## Consultation note regarding final model and documentation for geographical modification of DBA's fixed access LRAIC model

On the 8<sup>th</sup> of November 2017, the Danish Business Authority (DBA) sent the draft LRAIC model and documentation for the upcoming geographical modification of the fixed access LRAIC model to the industry for consultation. The modification includes the option of excluding chosen areas from the cost base in the fixed access LRAIC model, such that regulated prices only reflect regulated areas. The consultation period ended on the 29<sup>th</sup> of November 2017.

DBA received comments from two companies: TDC and Telia. Telia had no remarks. Below are the DBA's remarks to TDC's comments.

**Figure 1 : Area covered by a CO – Empty PDP**

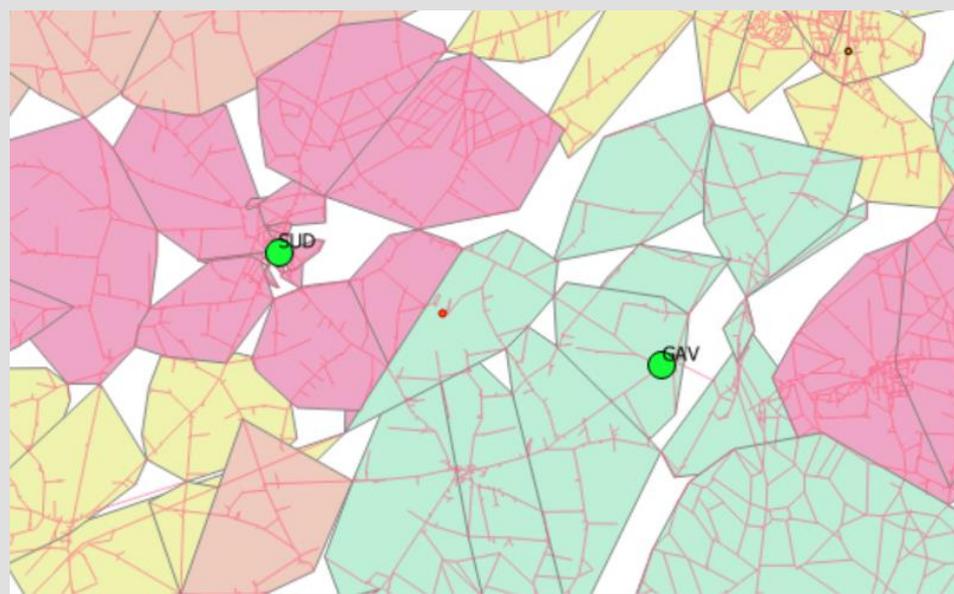
TDC has spotted eight COs with more than 10 pct. deviation between the old and the new model: (DAL, GAV, GBY HMM, KØ ØBL, RAB, SUD).

Among those eight COs, seven of these contain between one and four PDP with no active lines as listed in the below table. These inactive PDP has been removed.

Regarding the last CO GAV, this PDP (red dot) has no active lines and is connected to the CO SUD but is physically located in the GAV area (close to the SUD/GAV boundary) as shown in figure 1. Accordingly, the removal of this PDP will also affect civil engineering in the GAV area.
